COLPETZER-THOMAS, INC.
AN ENGINEERING GROUP

CONTRACT NO. 87-342

SHEPARD ROAD CO.

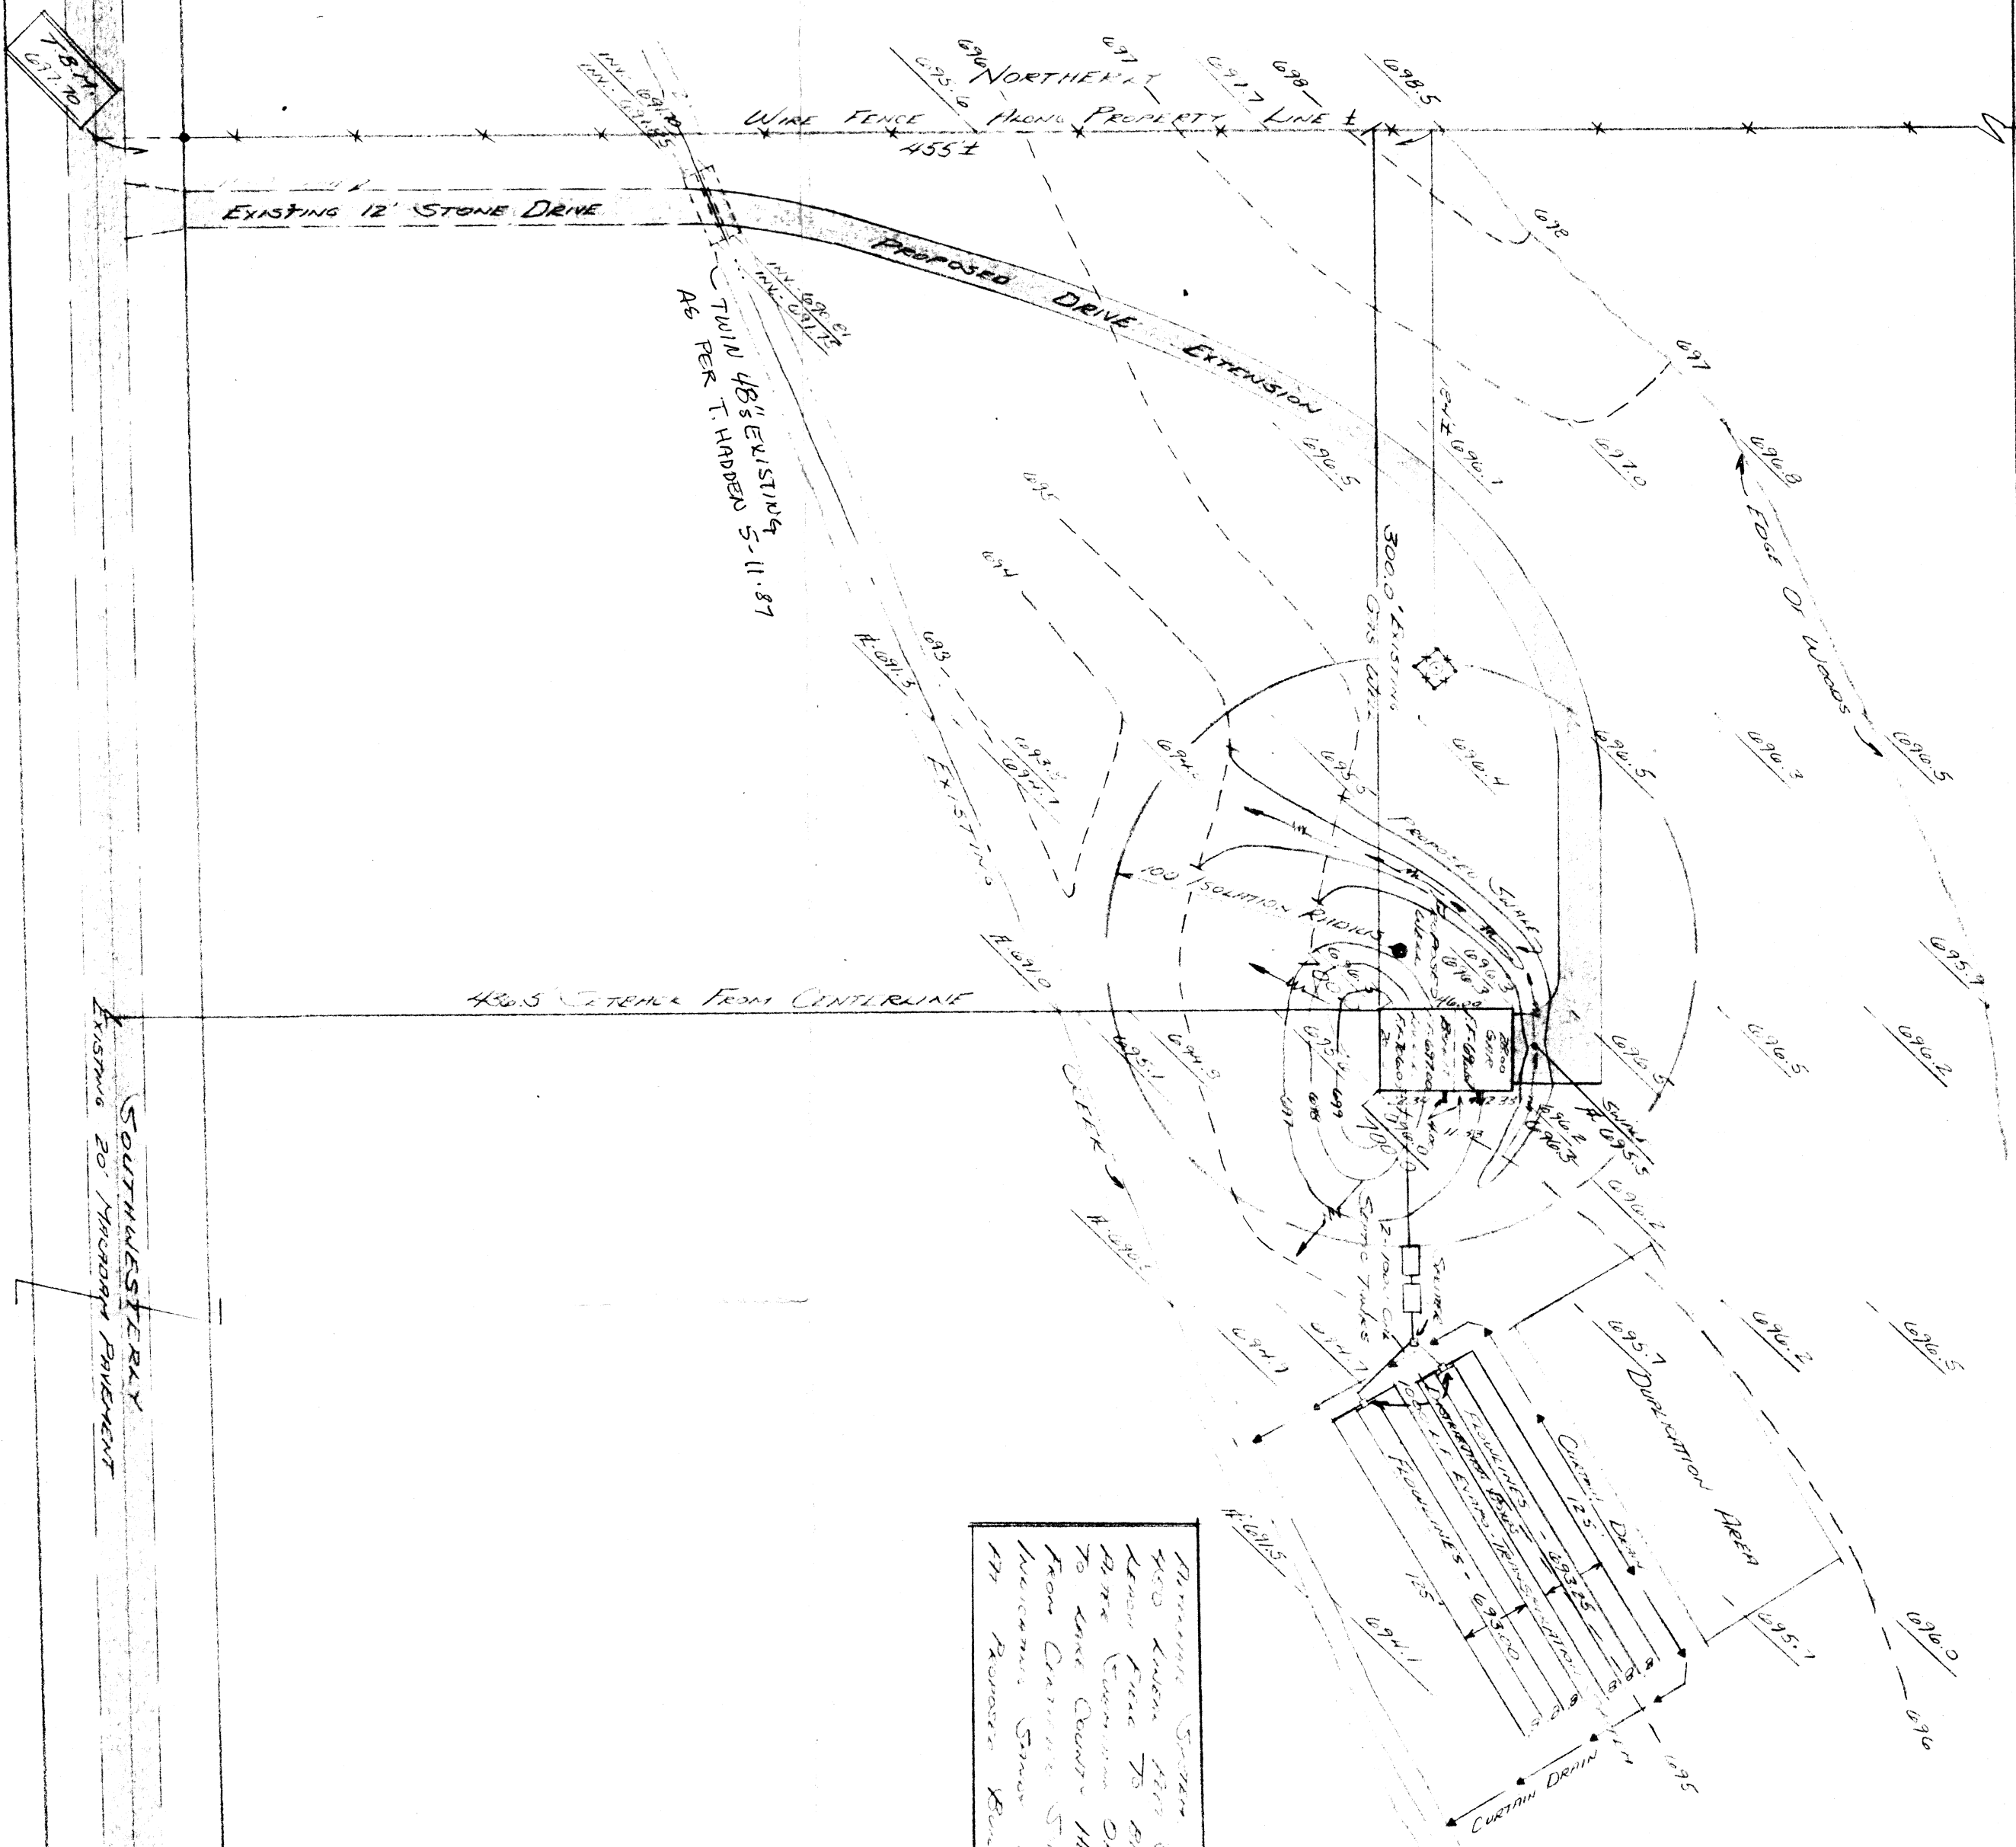
Minimum Slope of 4% known for or known from to be the same (minimum 2% to 4% to have clear water flow from driveway to storm sewer since the 17th Rowland Runway, etc.

Grading Plan Approved
as shown and/or noted
THOMAS P. GILLES, P.E.
Lake County Engineer
